Taco Bell - Rochester NY

RE: Proposed Taco Bell, 1737 Mount Hope – Response to site plan comments (SP-01-21-22)

We are in receipt of your Site Plan Review comments for the proposed Taco Bell at 1737 Mt Hope Avenue dated January 2, 2022. We have also received the Code Compliance Review spreadsheet as prepared by Ms. Marcia Barry on December 15, 2021. We appreciate that the City is willing to work with us to help alleviate the site plan concerns. The Zoom meeting on January 20, 2022 was very helpful.

Drawing Name:		Project No.	
Date: 07/27/20		20-0531	
Type: MD40			
Drawn By: SLA		SK2	
Scale: 1" = 20'		Drawing No.

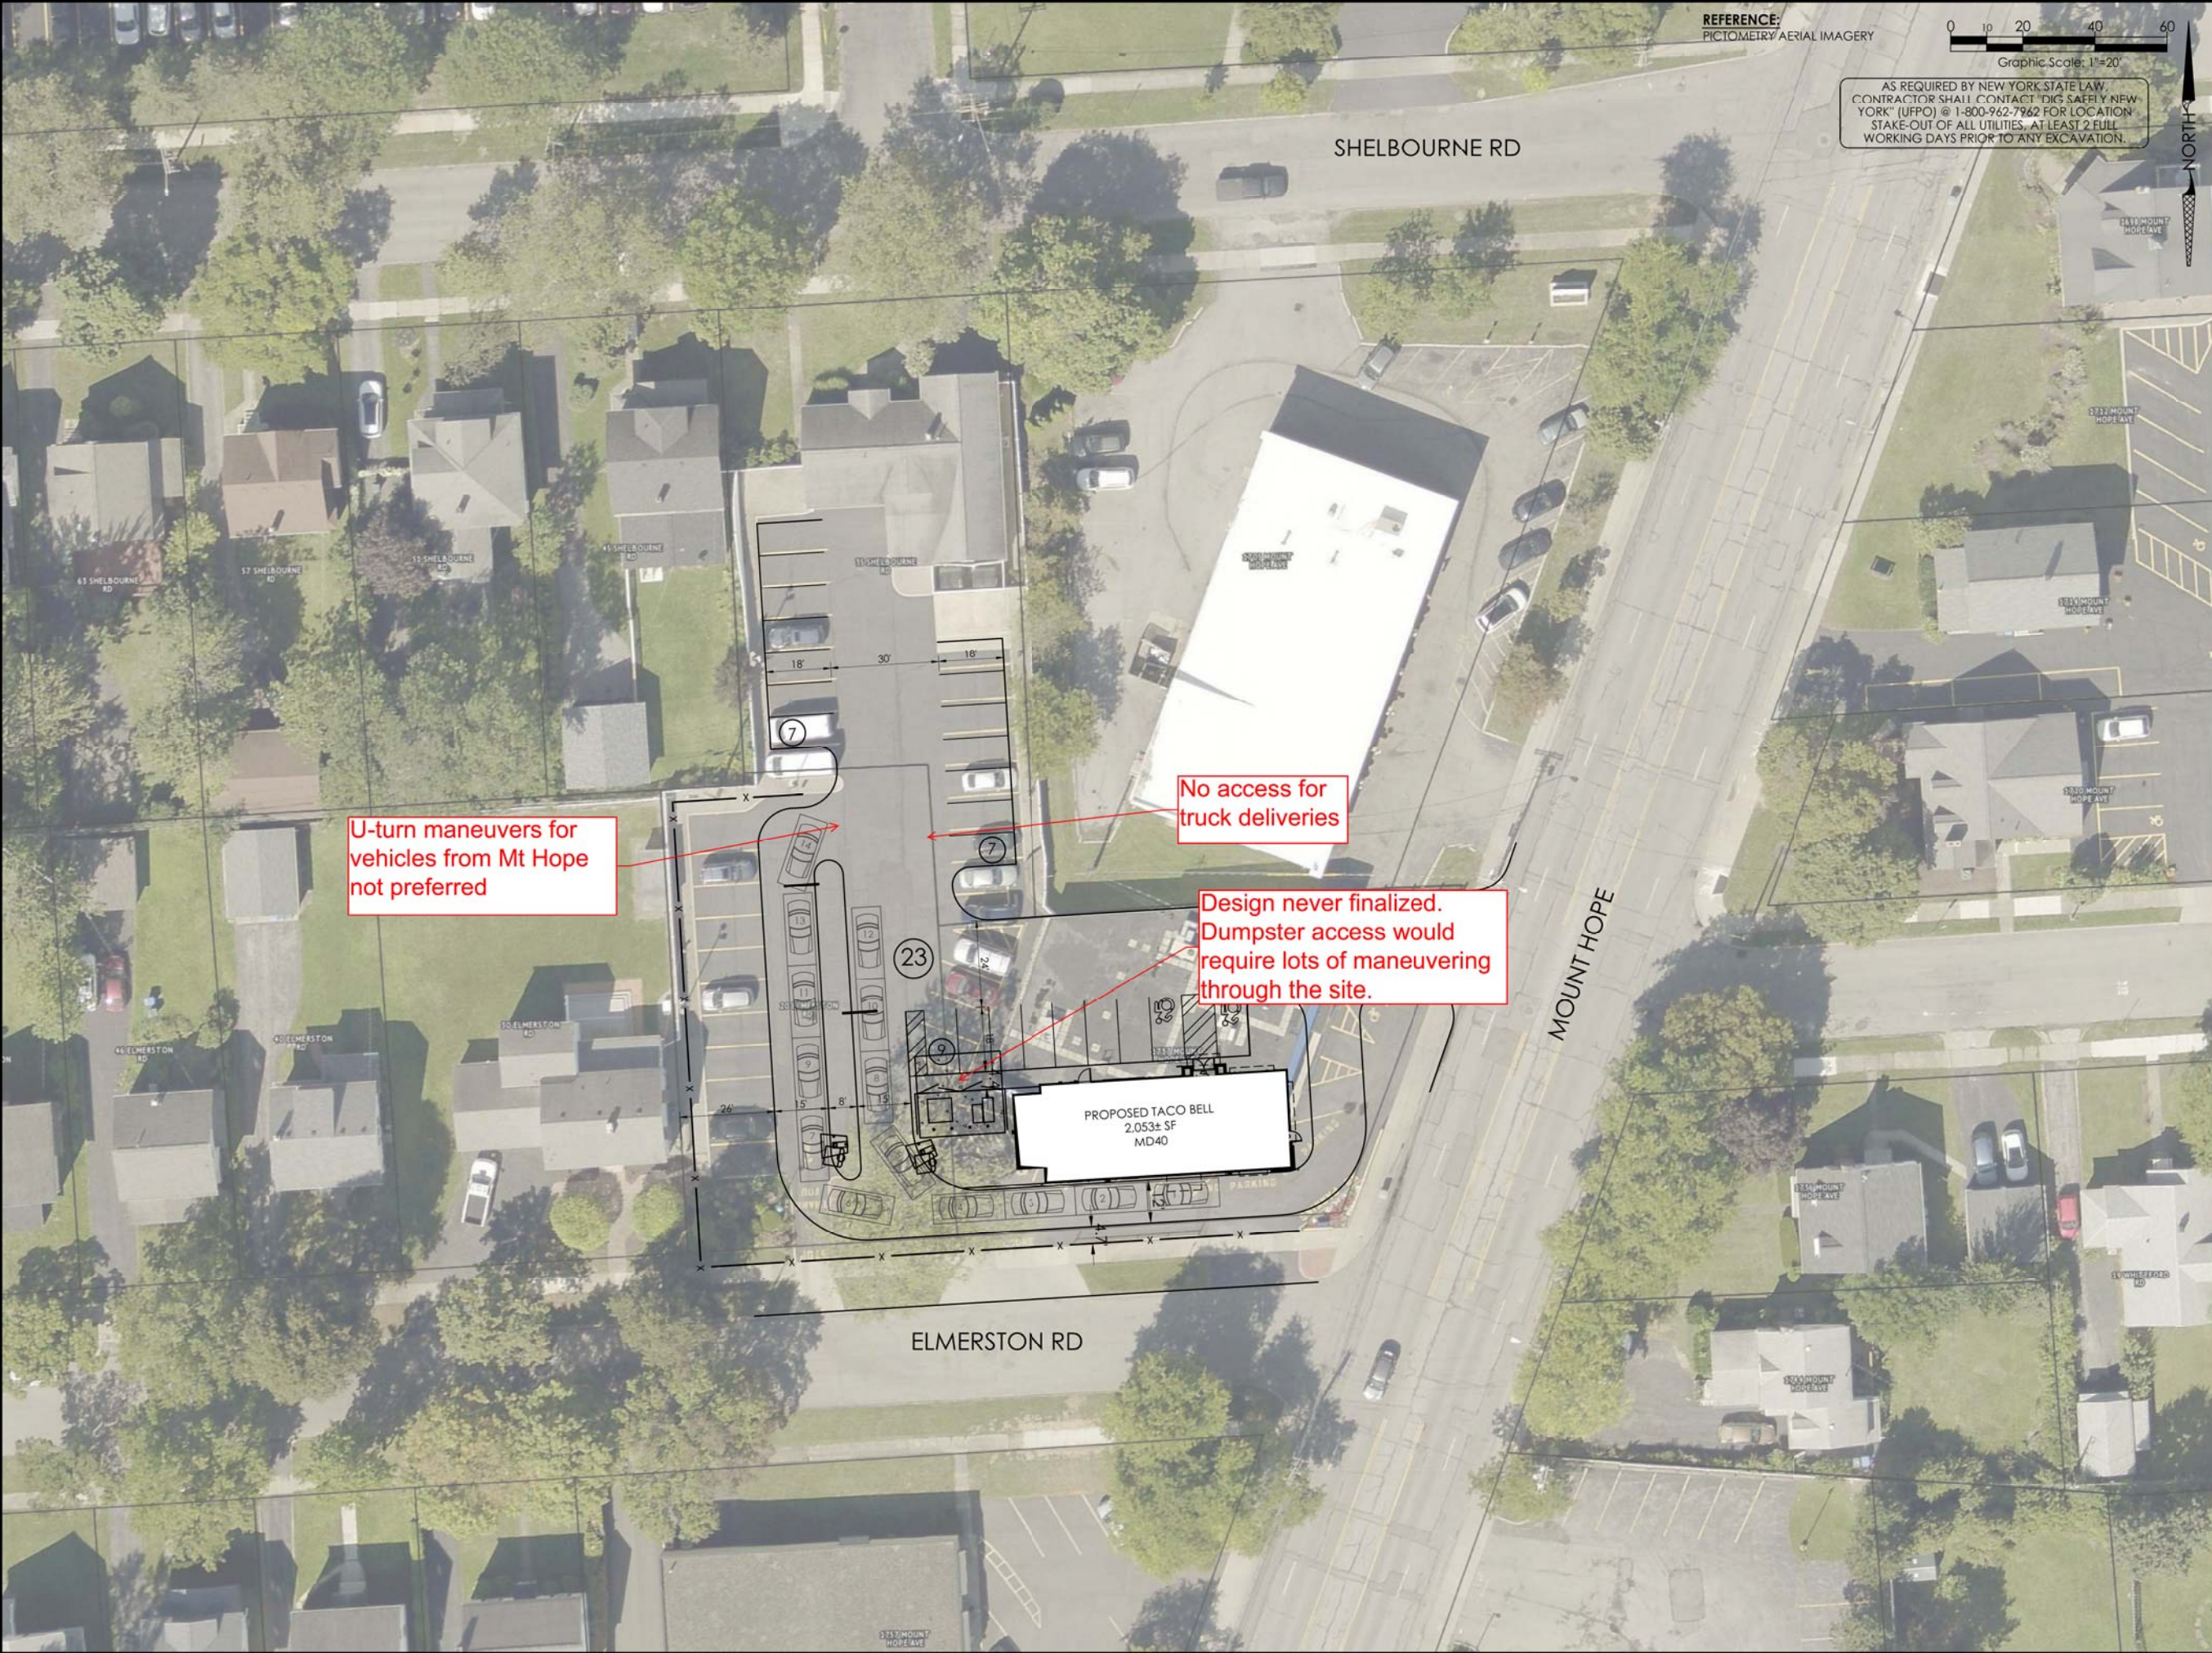
This site plan included the option to purchase the rental property from Mr. Rowe and see rezoning of this parcel as well to allow trucks to exit on Elmerston. We felt that this had a bigger impact to the residential neighborhood than a new curb cut lined up with Norfolk st.

Site Plan	
Drawing Name:	Project No.
Date: 07/27/20	20-0531
Type: MD40	
Drawn By: SLA	C2
Scale: 1" = 20'	Drawing No.

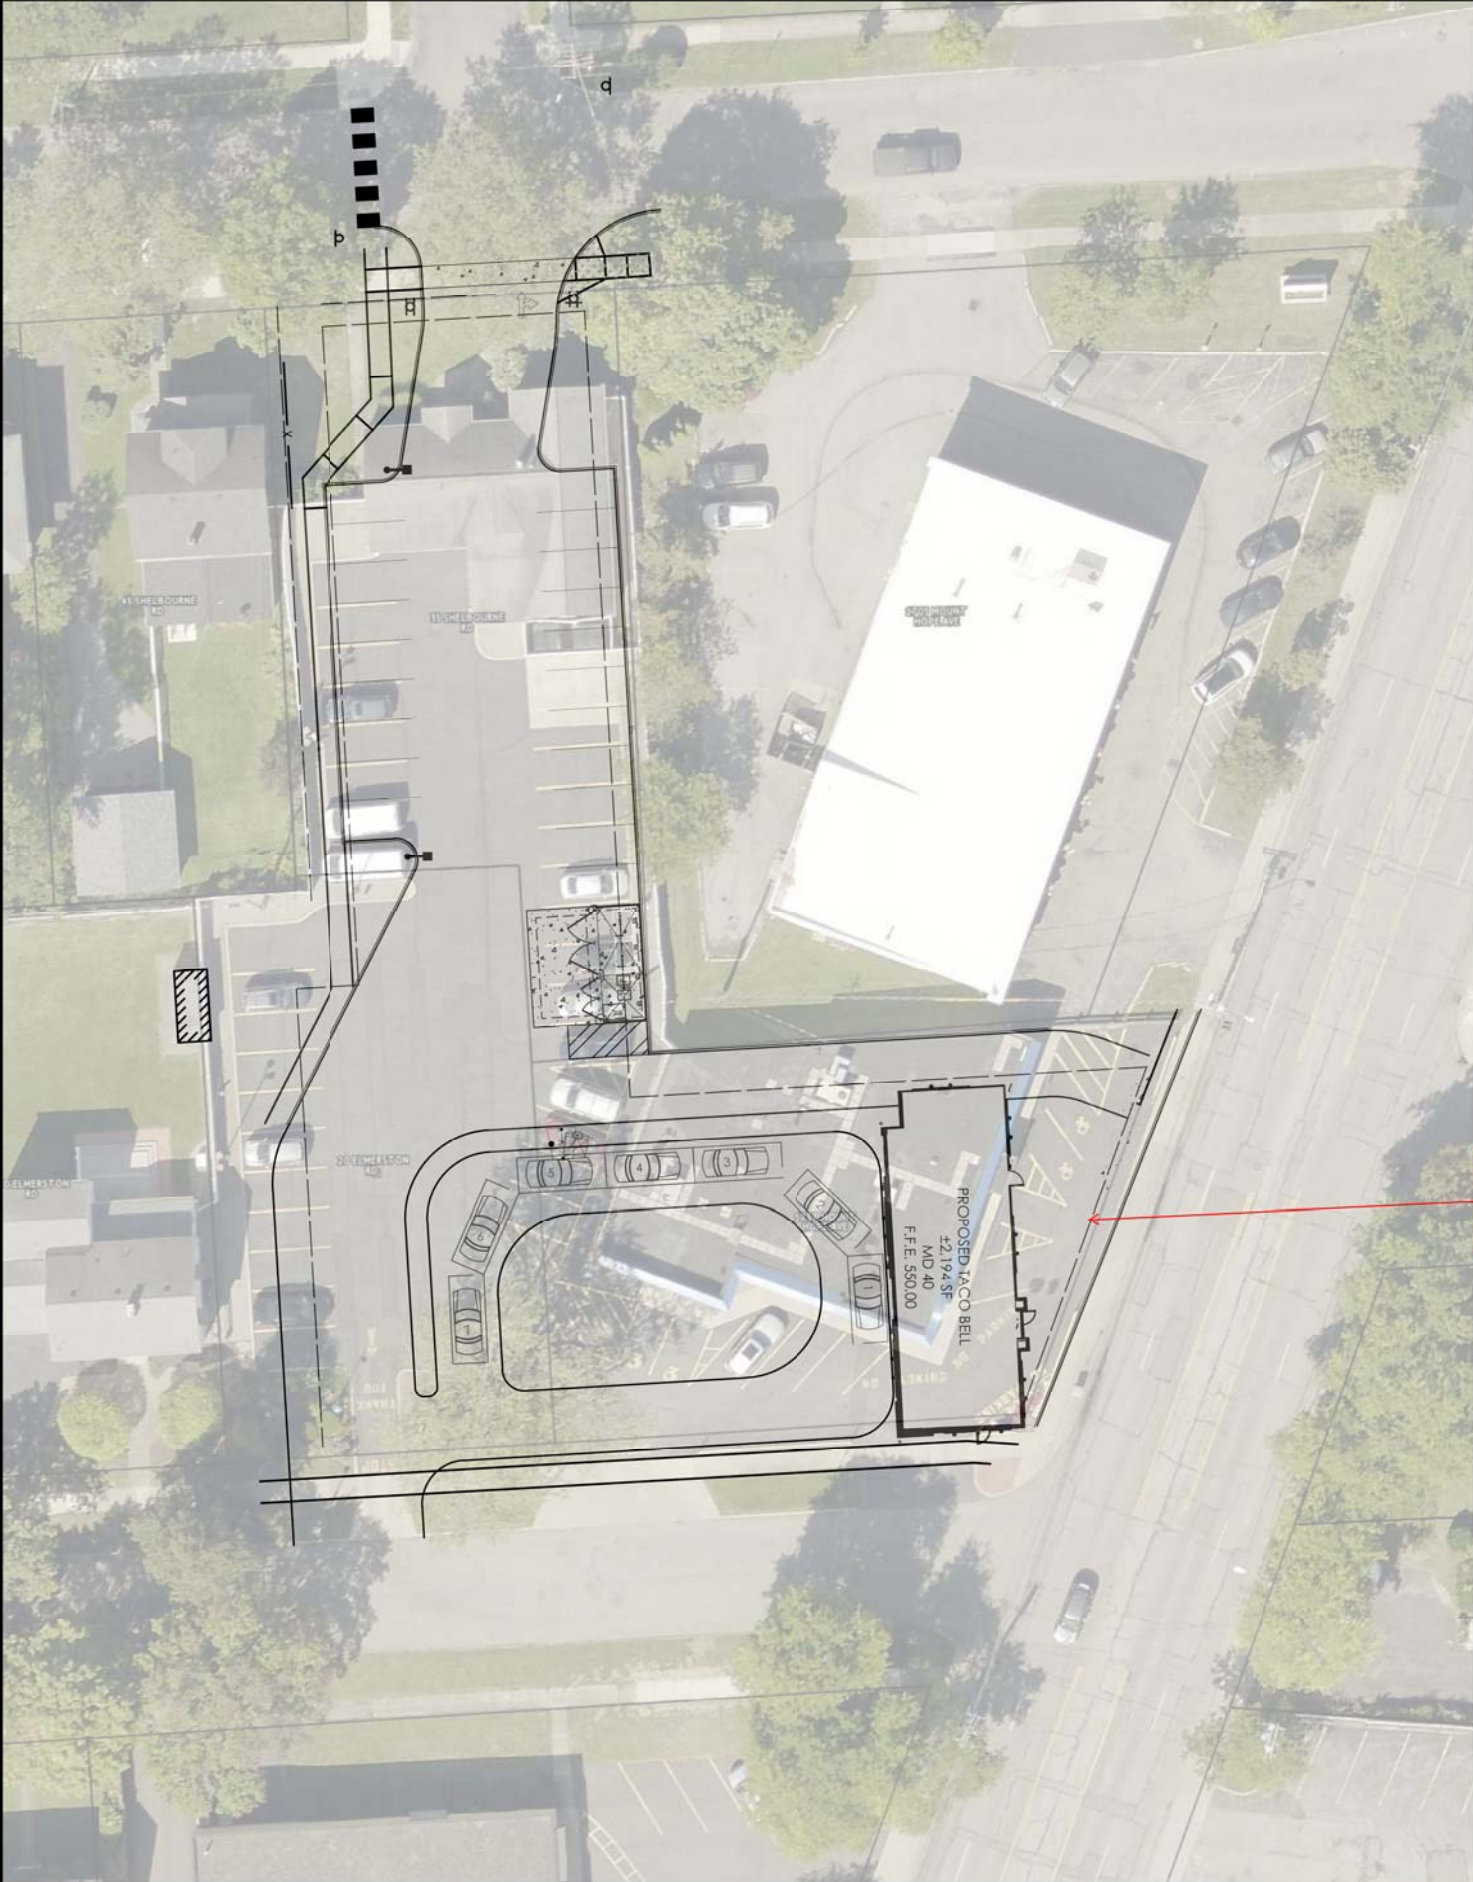
Same general comments as the last plan, but building is rotated along Elmerston and there is less stacking
